**NOTICE OF ADDENDUM
ADDENDUM NO. 1**

**CONTRACT NO. 7951
Capitol East District Parking Structure**

CONTRACT NO. 7951
Capitol East District Parking Structure

1D EXTERIOR ELEVATION - NORTH
A-510 1/8" = 1'-0"

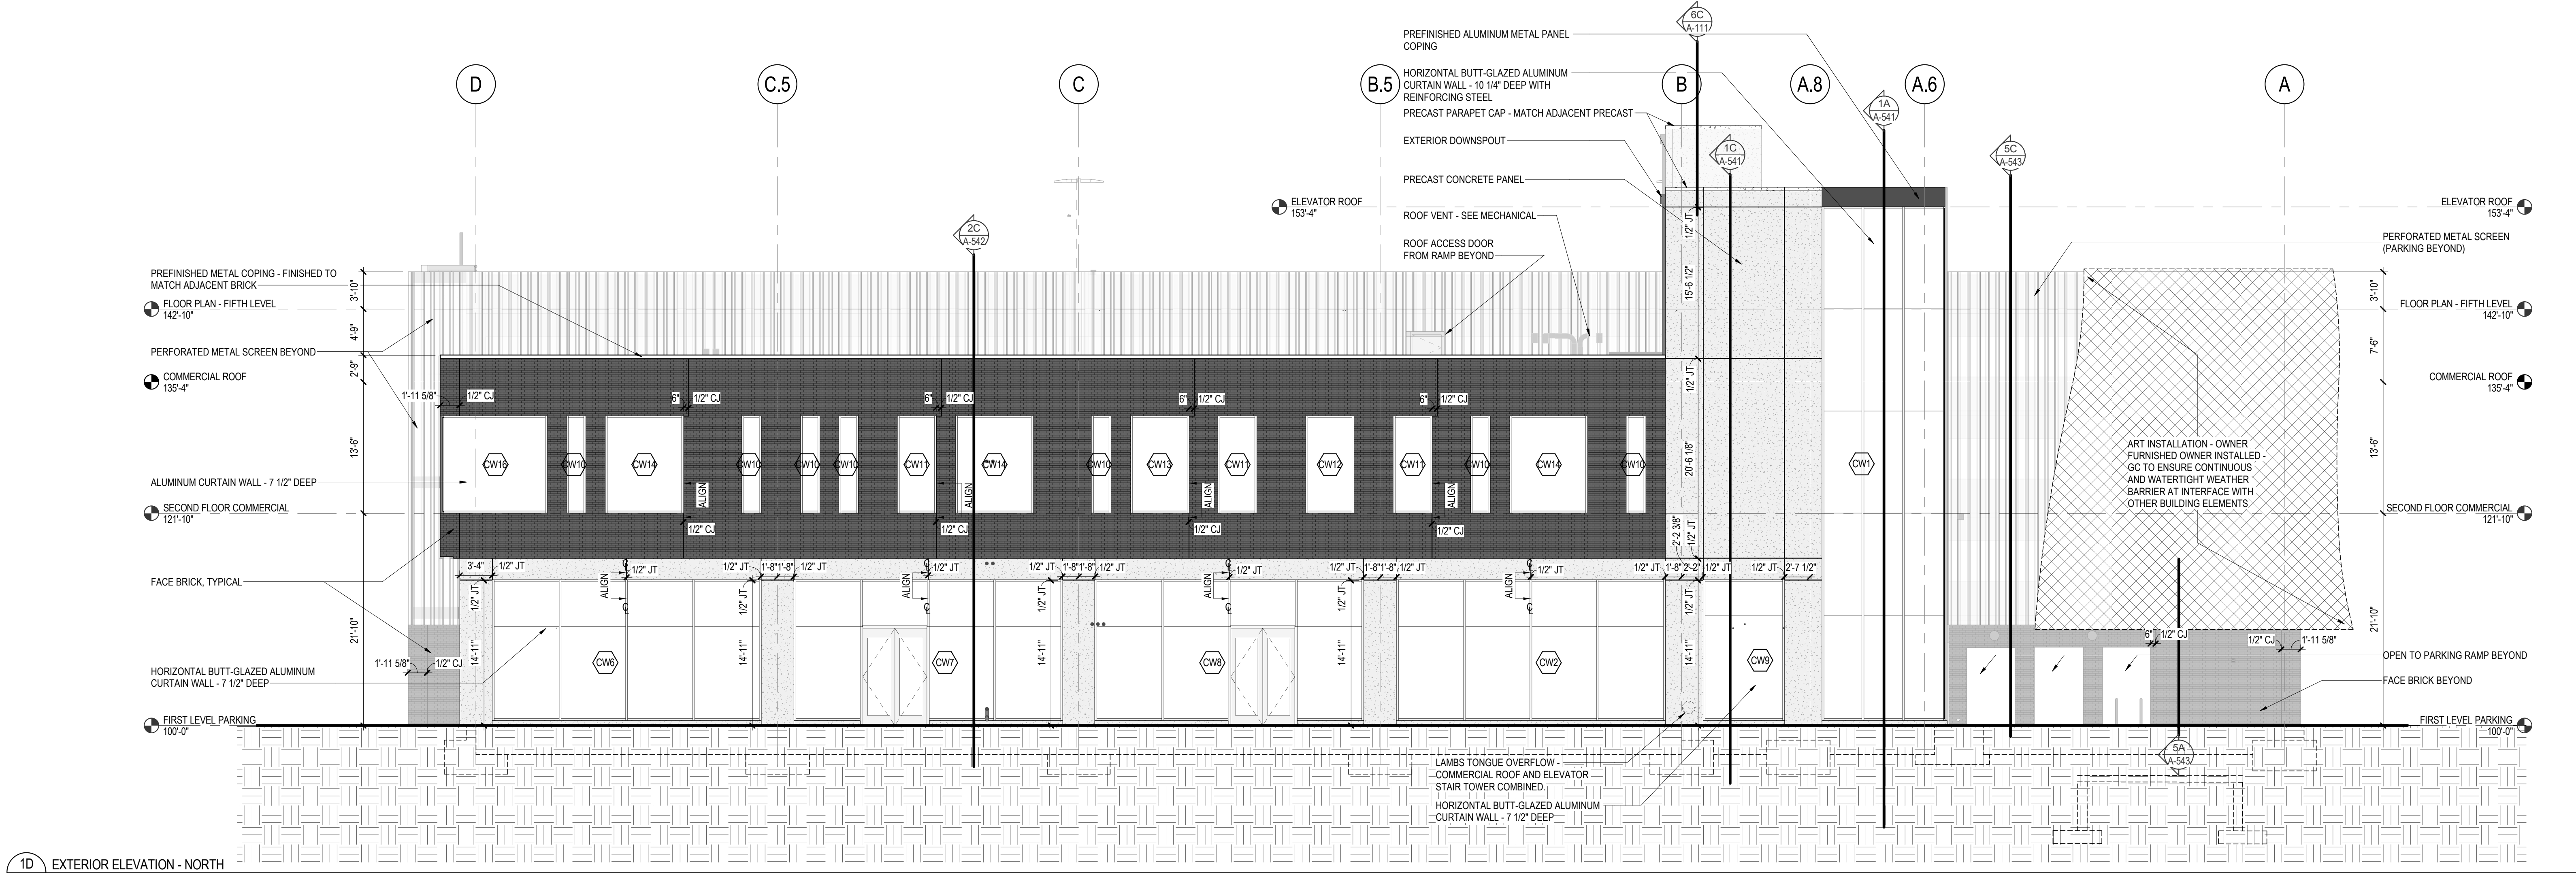
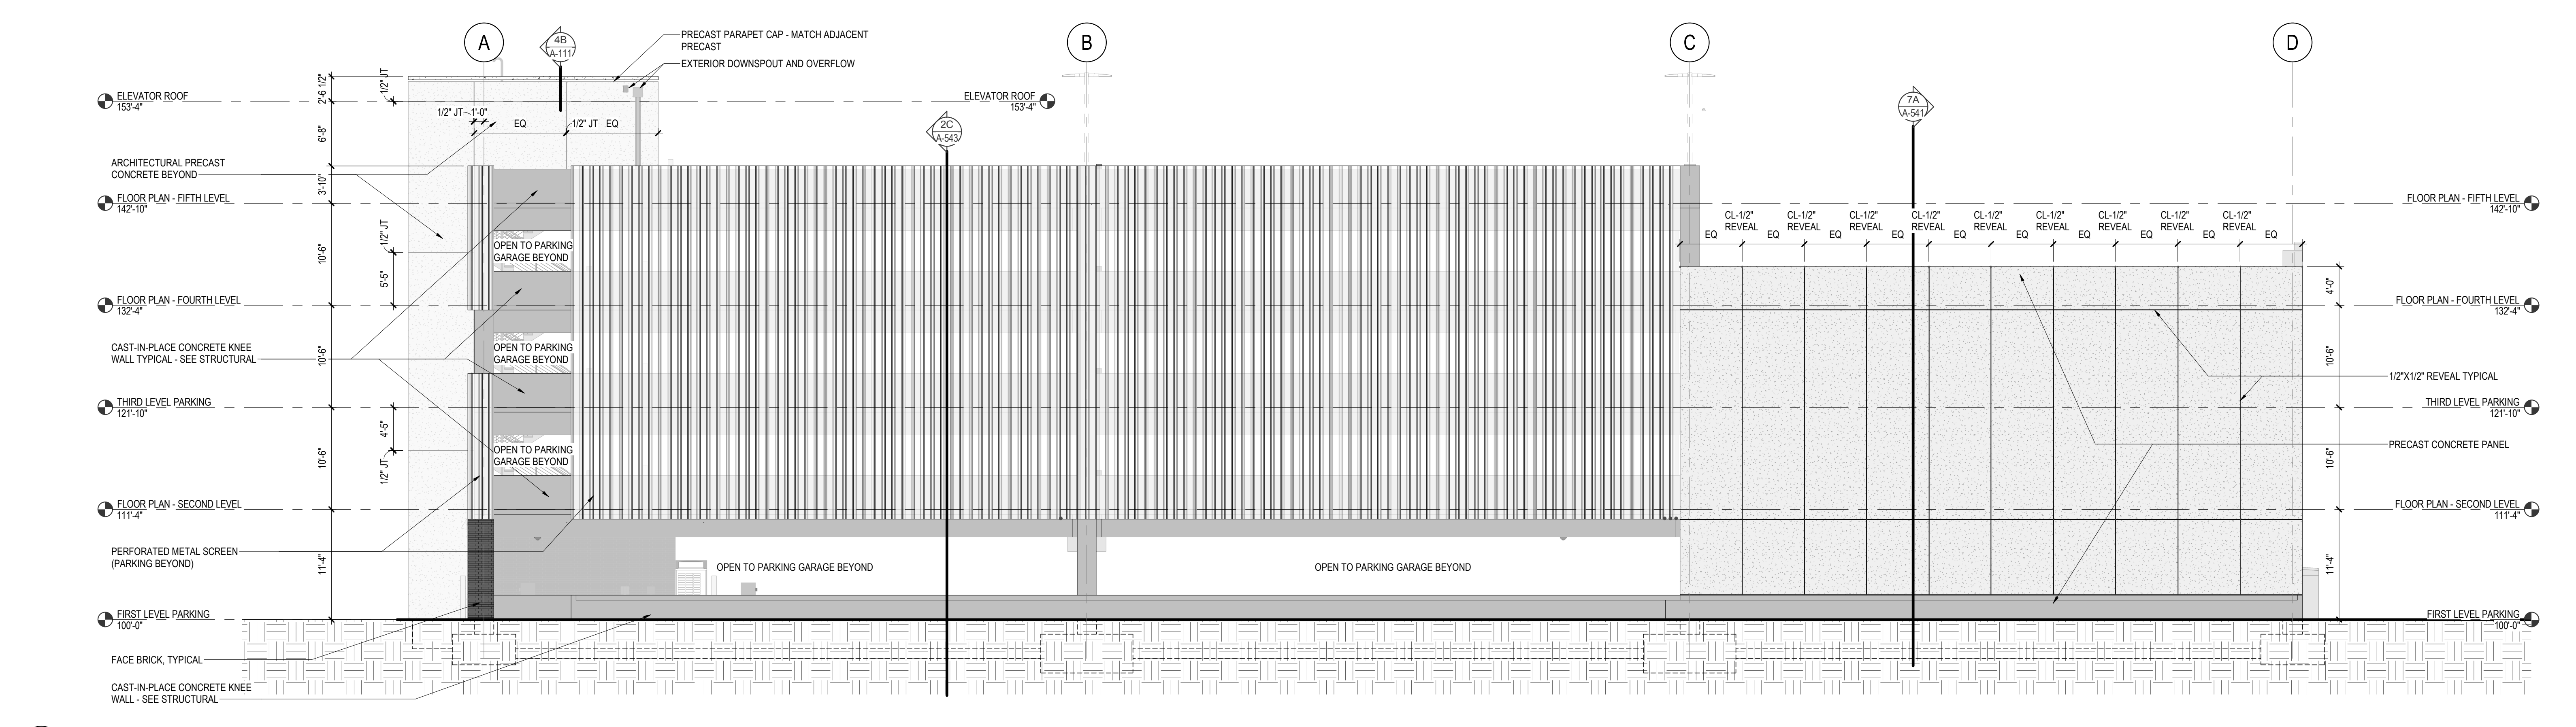
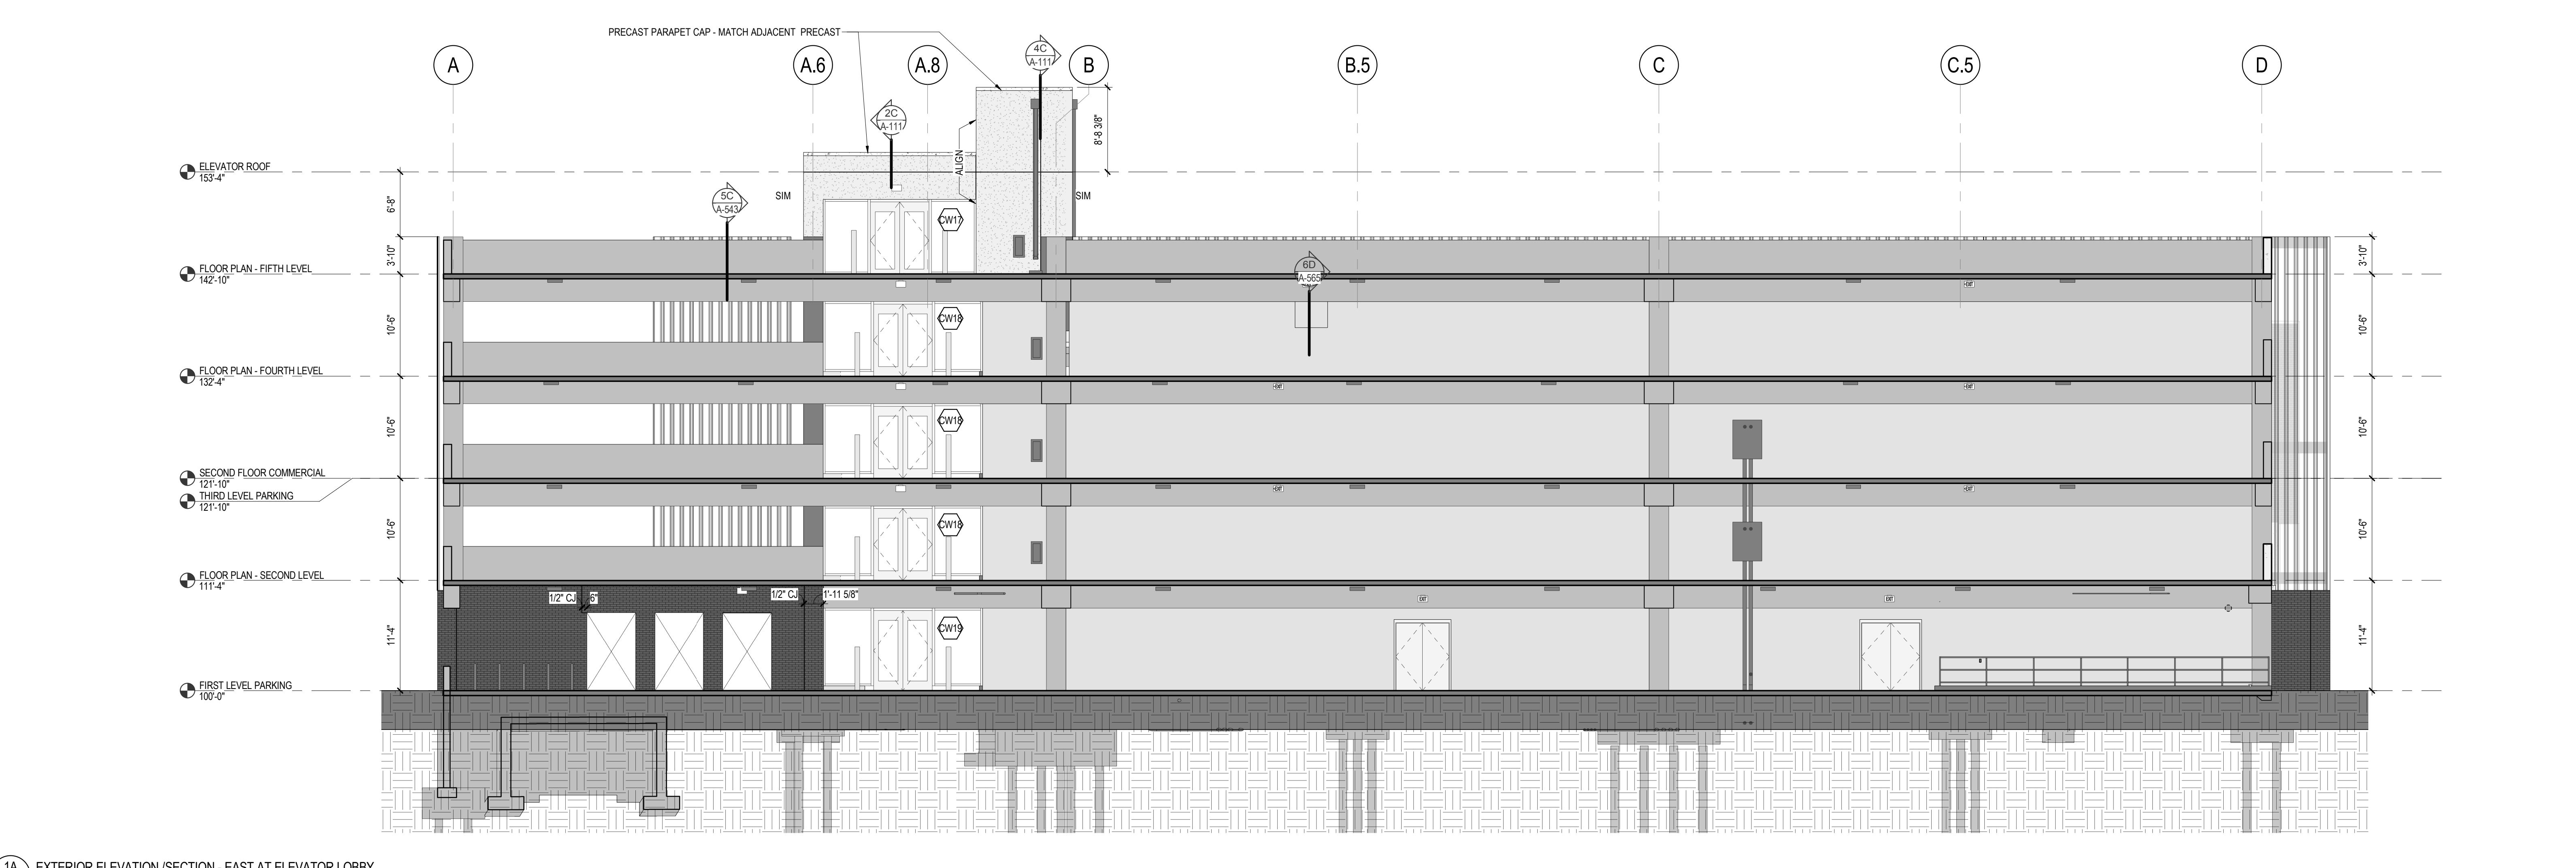
- I. A-450 – Partition Types (Reissued)
 - i. Revise as noted on reissued sheet.
- J. A-510 – Exterior Elevations (Issued)
 - i. Added elevations for clarification

1 LANDSCAPE PLAN
L-100
1/4" = 1'-0" on 30"x48" sheet

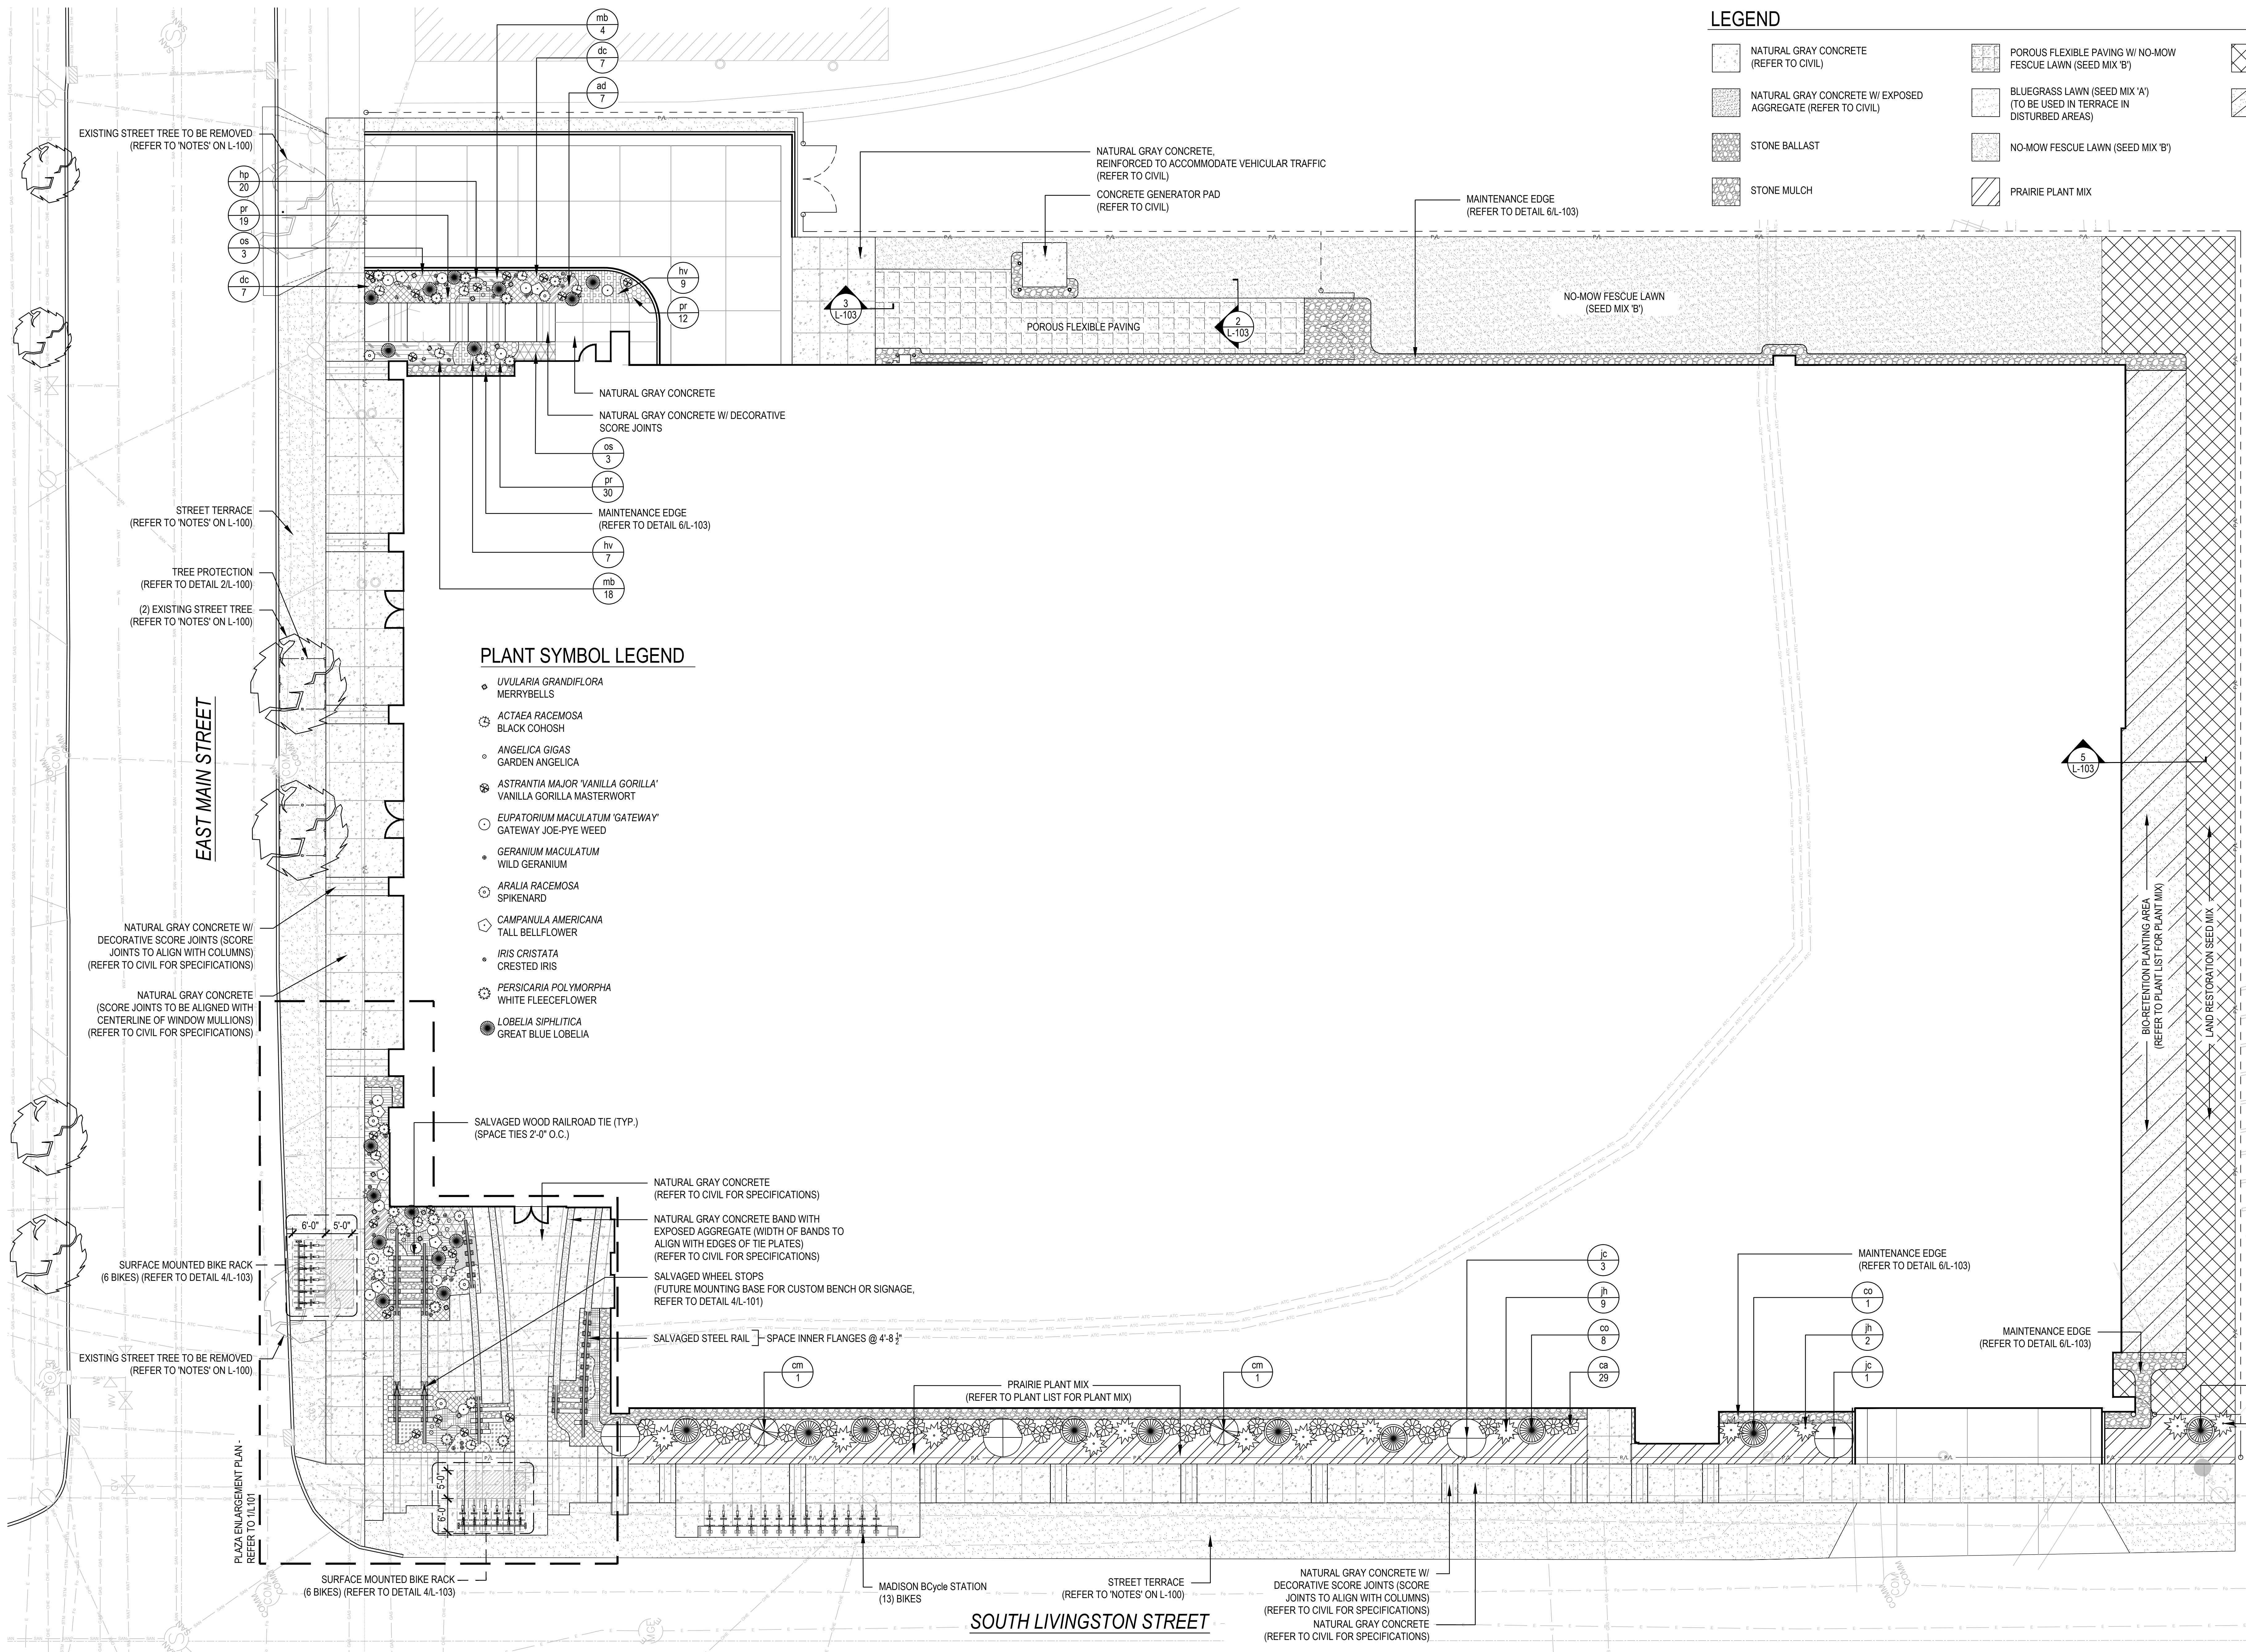
- A. L-100 – Landscape Plan (Reissued)
 - i. The pedestrian sidewalk entering the secondary entrance at the northeast corner of the garage has been widened to 5'-0". Refer to attached drawing.
- B. L-102 – Layout Plan (Reissued)
 - i. The layout plan now dimensions the new secondary entrance at the northeast corner of the garage as 5'-0". Refer to attached drawing.
